**Liddell Industrial Estate, 1-33 Liddell Road, London NW6 2EW – Minor-Material Amendment
Application to Vary Condition 2 of Planning Permission 2014/7651/P**

This application seeks to vary the approved plans within Condition 2 to accommodate design evolution and comments received from the Council. A summary of the proposed changes and the justifications can be found in subsequent sections. The proposed changes relate to Block C. No changes are proposed to Blocks A and B.

Figure 2: Location of Proposed Bike Storage

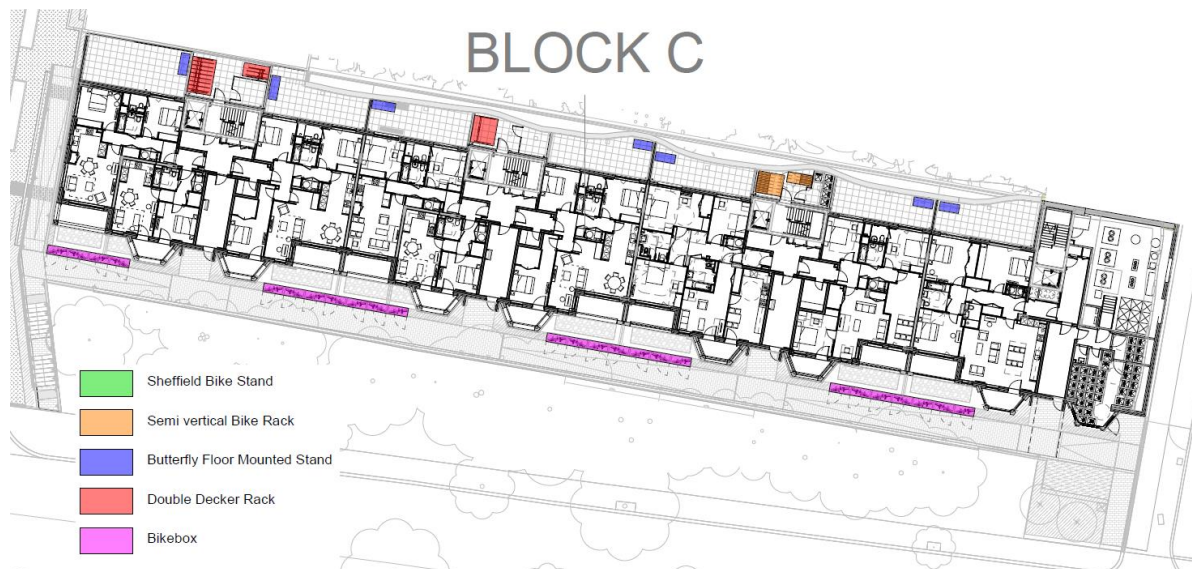
Further detail design development resulted in larger bin stores and plant rooms to align with current standards and statutory requirements. We are therefore proposing to relocate 50 cycle storage spaces to a more dispersed distribution throughout the site. The proposal is to utilise the boundary of the front gardens of Block C, along the building's south elevation. Drawing ref. BM-BC-00-DR-A-03-0000 provided with this planning application, will replace the consented drawing MLA-403-P2-170 REV A.

Figure 2 show the proposed location and type of bike storage at Block C, as follows:

- 41 bikes to the consented storage areas at the back of Block C. This comprises 9 semi vertical bike rack spaces and 32 double decker spaces.
- 14 bikes within butterfly floor mounted stands to the ground floor apartments to their private rear courtyards.
- 50 bikes to the front of the gardens, within bike boxes.

The cycle storage at the front of Block C (shown in pink in Figure 2) will be in the form of high quality secure bike boxes with landscaping on top. This will provide an efficient design solution which also provides cycle storage in more convenient location for residents.

The bicycle sheds would be clad with hardwood and fixed to a concrete plinth. A planter would sit on top of the sheds, with the plant species to be specified by the Landscape Architect. For security reasons, the sheds would be designed to appear as a garden wall planter rather than as bike storage. Hedges would be located either side of the sheds.
